Our Ref: 36519-001-02
Your Ref: MCUC 2025_5867/1

**Information Request Response – Development Application MCUC 2025_5867/1
Material Change of Use for Short Term Accommodation (intensification of existing
backpackers accommodation)
37-39 Warner Street Port Douglas – Lot 50 on RP896319**

Port Douglas Backpackers, MCU for Short-term Accommodation Intensification – Traffic Impact Assessment

1 GF Landscape and Communal plan
1:100 @ A3

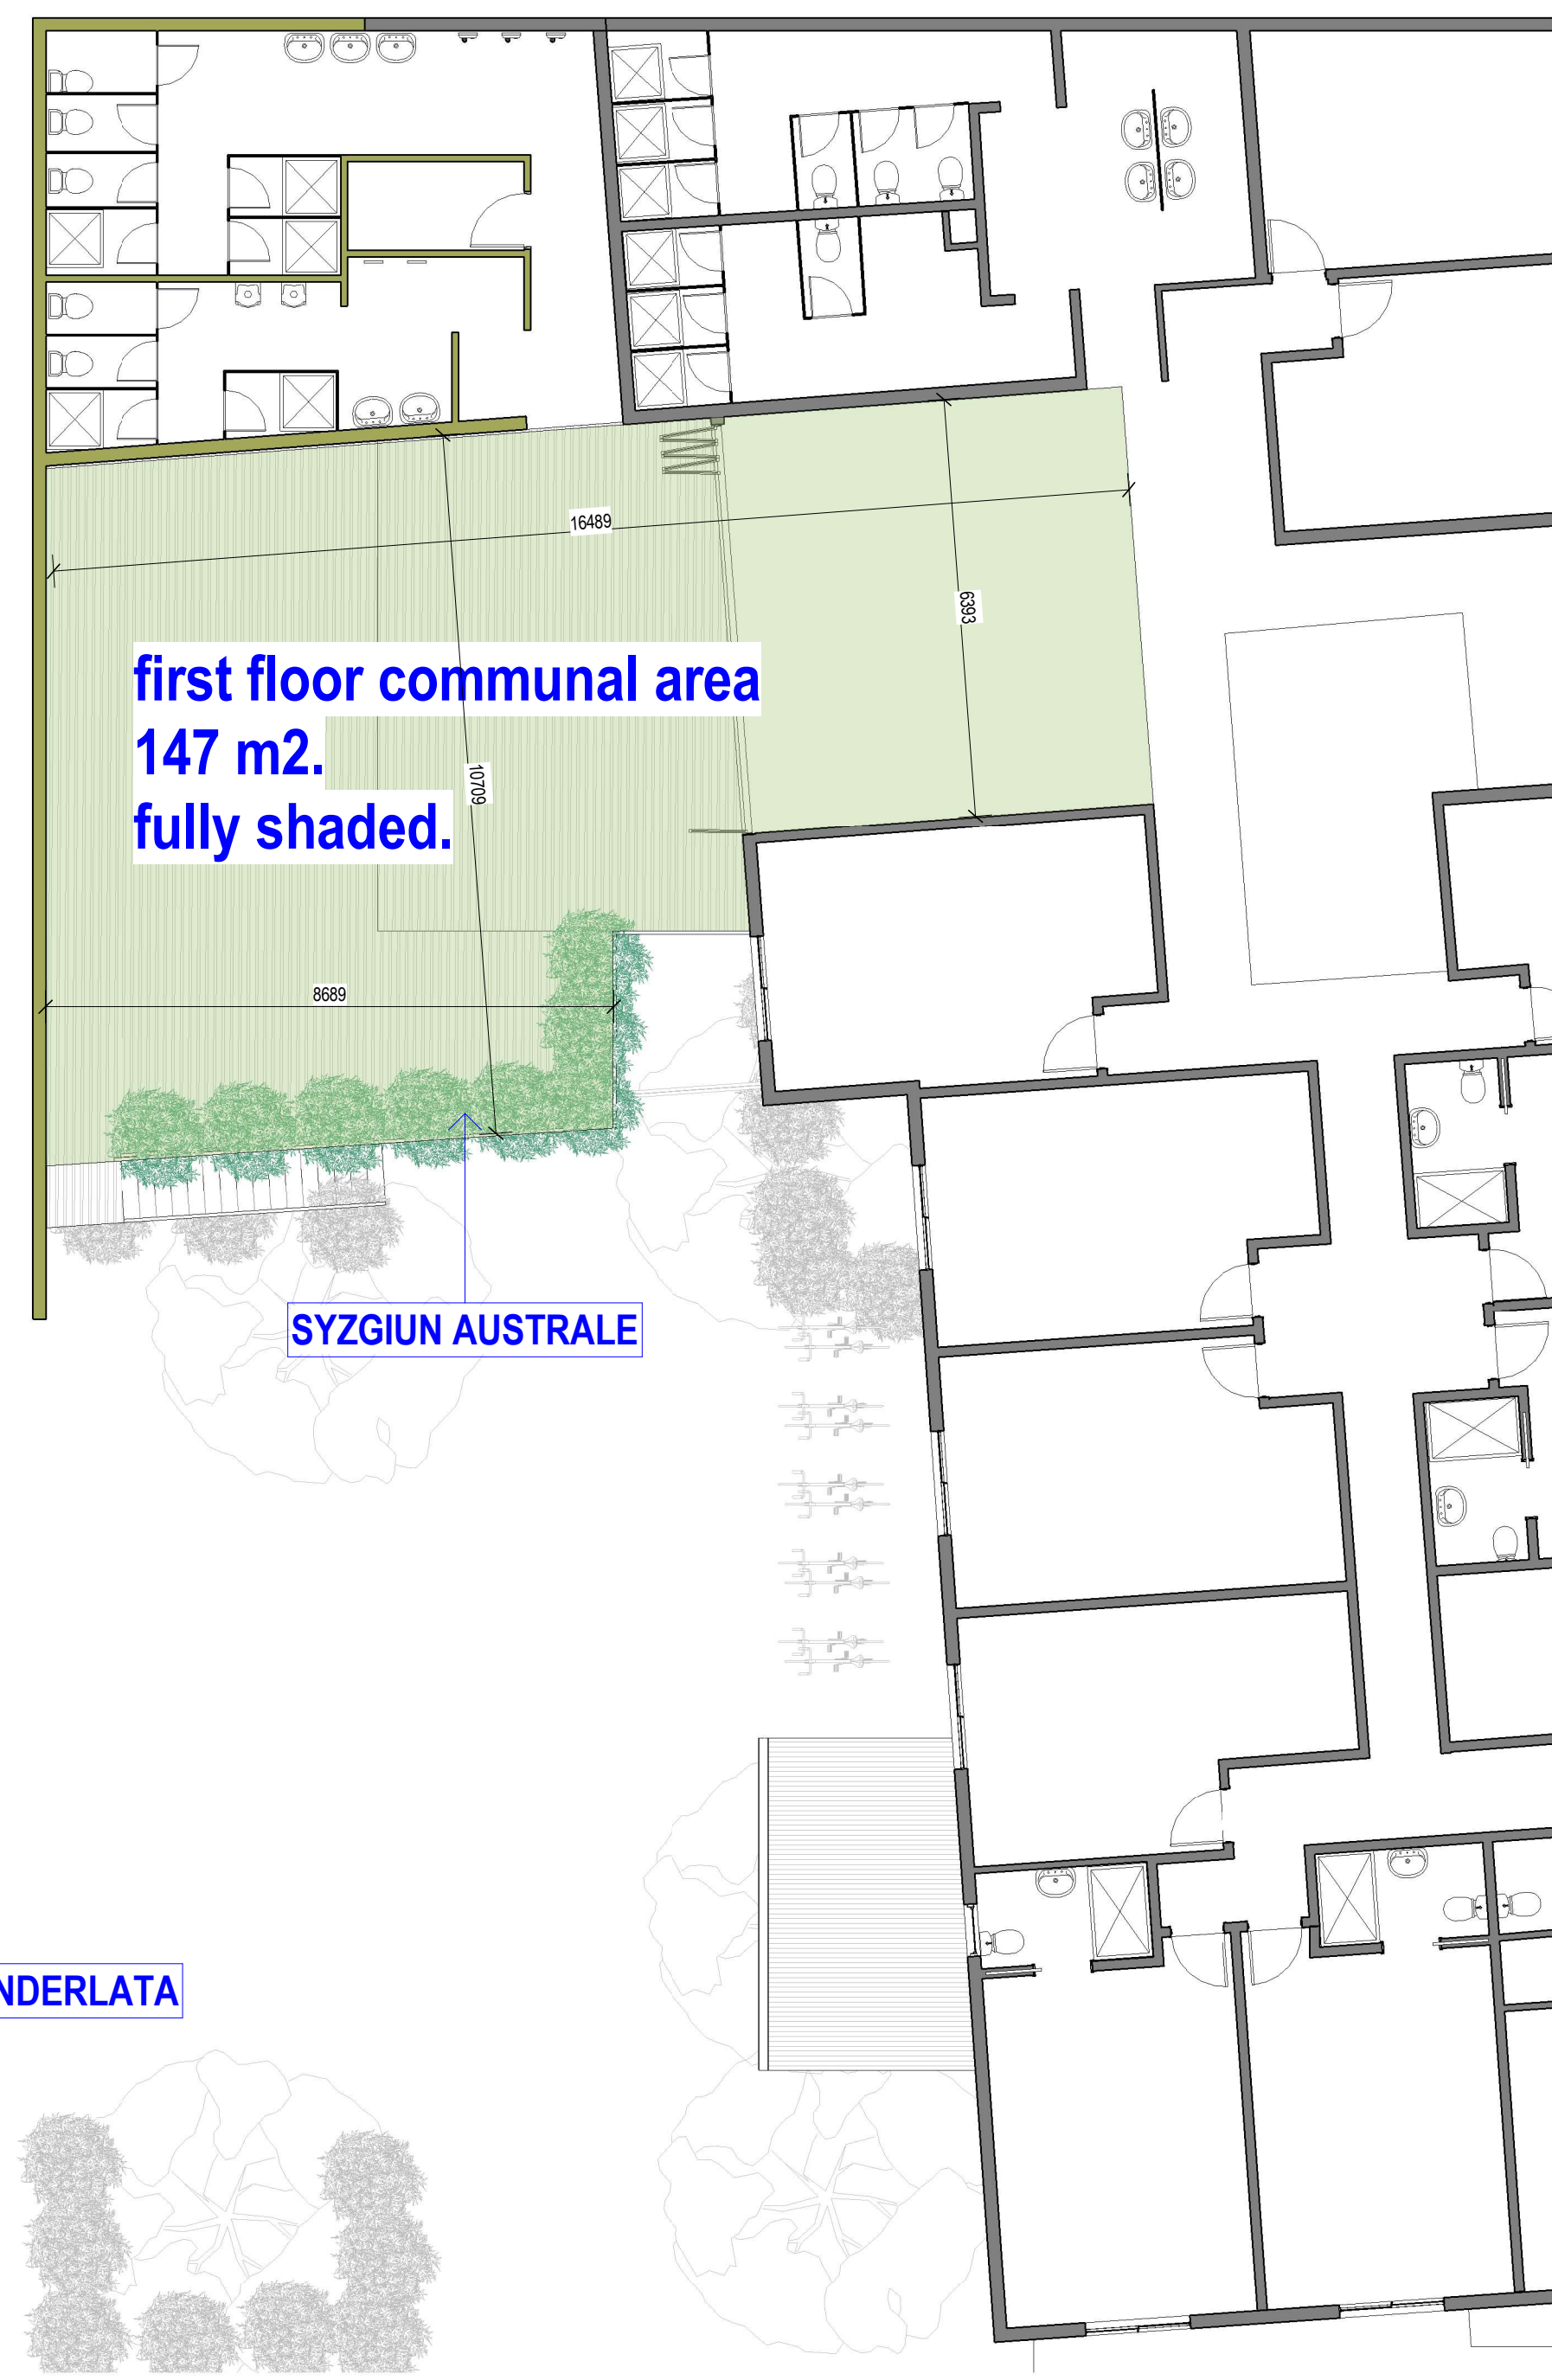
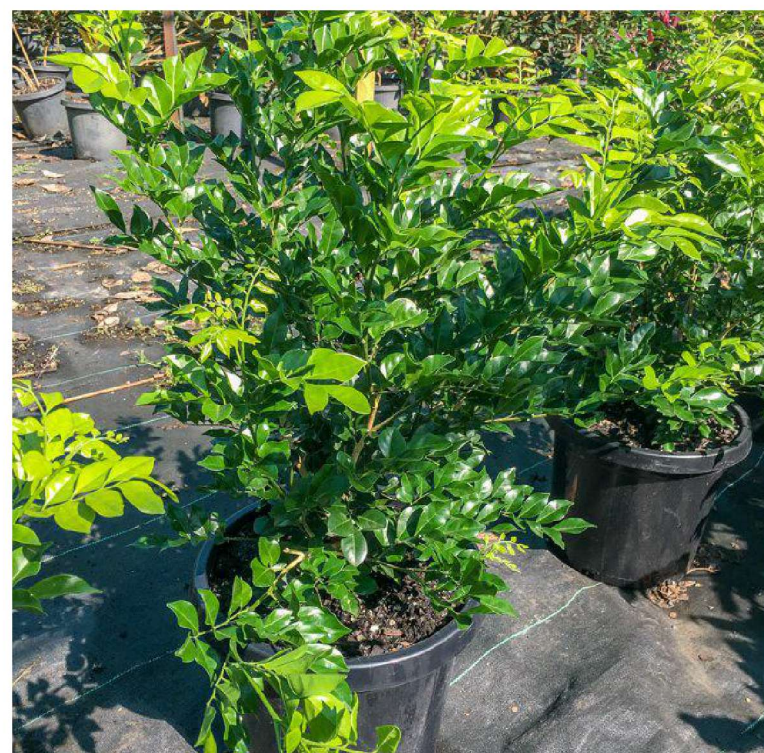
5. *Please provide a scaled plan showing the dimensions of personal and communal open space available to each guest. The Plan should include the percentage of each open space that is open to the sky and shaded by trees.*

6. *Provide a landscape plan detailing the location of existing and proposed landscaping. The landscaping should consider the requirements of the Planning and Environment Court judgement issued on 9 April 2001 (Ref: Appeal No. 1 of 2001) and Council's Planning Scheme Policy No.7-Landscaping.*

- *Existing mature trees marked for retention and removal;*
- *Existing and proposed landscaping showing plant species, planting schedules and maintenance regimes; and*
- *Existing and proposed hardscape features.*

Please refer to a copy of the communal plan included at Drawing A08 of the amended Proposal Plans prepared by 8 Pencils included within **Attachment B**. The plan demonstrates a combined outdoor communal area of 352m² across the ground and first floor. The ground floor communal area comprises 58.24% of the available communal open space and is open to the sky and adjoins existing landscaped areas.

Please refer to a copy of the landscaping plan included at Drawing A08 of the amended Proposal Plans prepared by 8 Pencils included within **Attachment B**. All vegetation will be retained with the exception of one (1) existing tree to be removed.

The removal of the tree is required to accommodate the new deck expansion. A new raised planter is introduced to the proposed first floor deck expansion to soften the built form and improve amenity of users and the public.
